OORR PROGRAM
DeLuca Residence
411 Blohm Street
Hamden, CT
Project #: 2140

BID PACKAGE
FOR
REHABILITATION/RECONSTRUCTION WORK TO
DELUCA RESIDENCE
411 BLOHM STREET
WEST HAVEN, CONNECTICUT

ADDENDUM NO. 1

LSU/LSSU *Adjustable Light Slopeable/Skewable U Hangers*

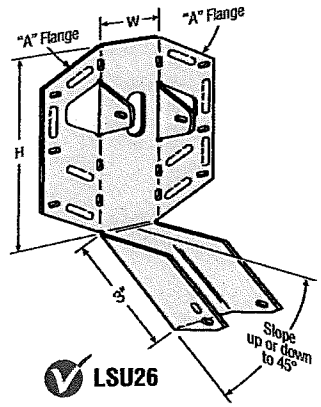
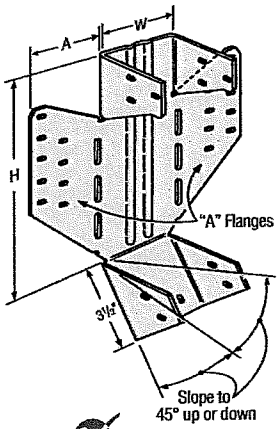
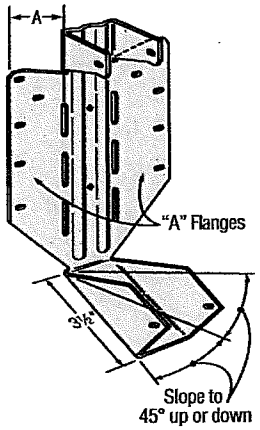
2. CONTRACTOR SHALL INSTALL LSU/LSSU CLIPS BY SIMPSON STRONG-TIE AT THE CONNECTION OF EACH JACK RAFTER AT THE VALLEY. SELECT APPROPRIATE CLIP TO FIT CONNECTION. SEE ATTACHED PRODUCT INFORMATION.
